NEBRASKA CAPITOL ENVIRONS COMMISSION

NEBRASKA CAPITOL ENVIRONS COMMISSION STAFF REPORT

APPLICATION NUMBER	Urban Design Record #23086
APPLICATION TYPE	Certificate of Appropriateness
ADDRESS/LOCATION	440 S 13 th Street
HEARING DATE	June 23, 2023
ADDITIONAL MEETINGS	April 28, 2023
APPLICANT	David Wiebe, Architectural Design Associates, davidw@adalincoln.com
STAFF CONTACT	Collin Christopher, 402-441-6370, cchristopher@lincoln.ne.gov

UDR23086 – Nebraska Council of School Administrators Building (440 S 13th Street)

ATTACHMENT B - Landscape Plan

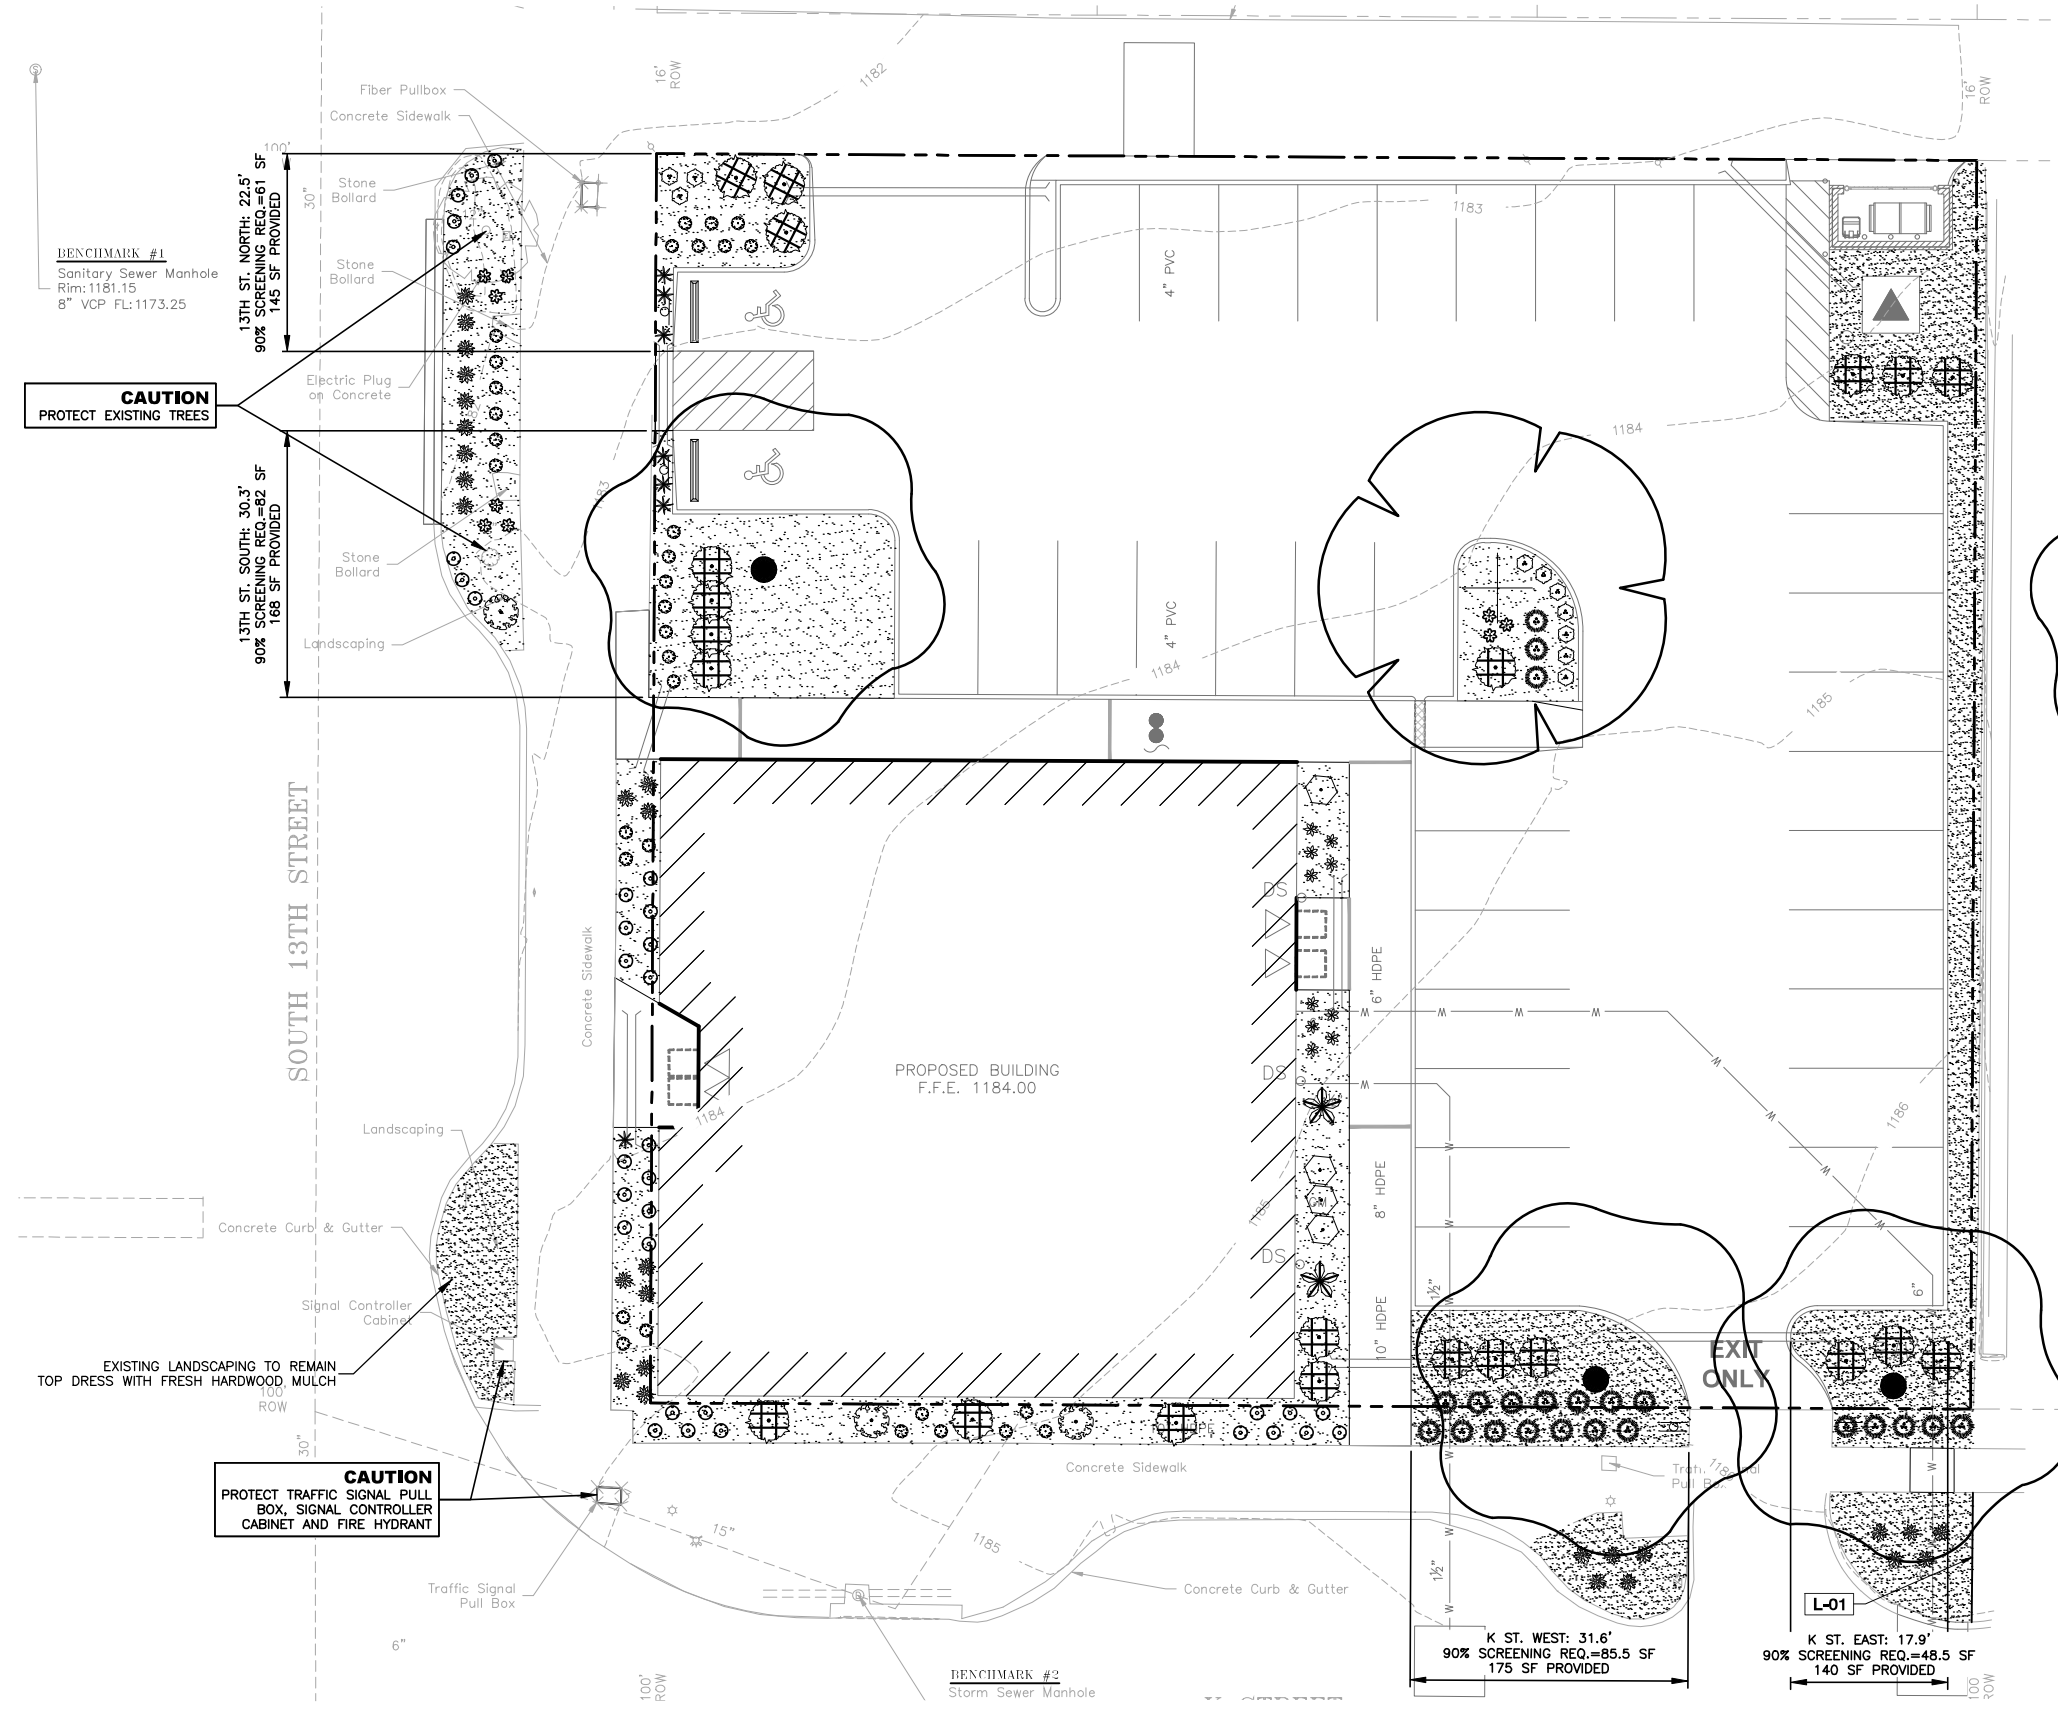
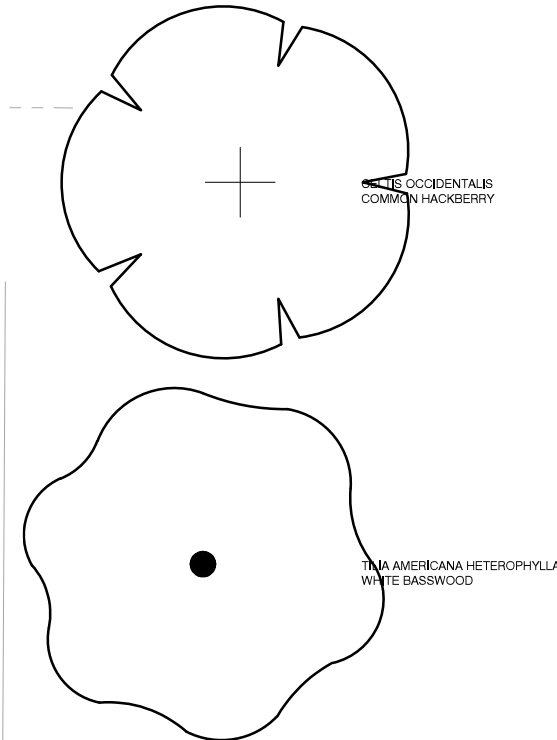
- **Parking lot screening** – Screening is required around the entirety of the perimeter of the parking lot in the downtown, unless otherwise screened by a building structure on the property. This means that per the standards, both the north and east perimeters should be screened. The north perimeter runs adjacent to an alley that is not curbed and trying to maintain landscaping in this area would admittedly be a challenge. The east perimeter abuts a neighboring building, and the applicant saw limited value in providing screening along this edge. In order to offset the lack of screening along these two sides, the applicant has proposed restoring the beds in the public right-of-way along S 13th and K Streets. Further, they are also showing new foundation plantings along 3 sides of the proposed building,

- **Parking lot trees** – A parking lot of this size requires two internal parking lot trees, which the applicant has provided.
- **Street trees** – Street trees are required, where space allows, along both S 13th and K Streets. There are currently two existing trees along the S 13th Street side. Though the trees are smaller than typical street trees, they are both close to an overhead utility line and staff recommended retaining the existing trees instead of attempting to plant a larger tree that LES would likely not allow. Along the K Street side, the applicant is proposing two new trees. While the proposed trees are technically on private property, they will function like a street tree and add definition to that edge.

While there are certainly some deviations from the design standards in this proposal, the applicant has made a clear effort to work with city staff to come up with a solution that meets the intent of the standards. The highlighted deviations have been offset by additional landscaping in other areas that would not otherwise be required. As such, staff is of the opinion that the proposed plan will add value to the environs and the larger downtown district.

Recommended finding: The proposed landscape plan generally complies with the intent of the Capitol Environs Design Standards and the Screening and Landscaping Design Standards.

Recommended action: Approval of a Certificate of Appropriateness for the landscape plan at 440 S 13th Street.
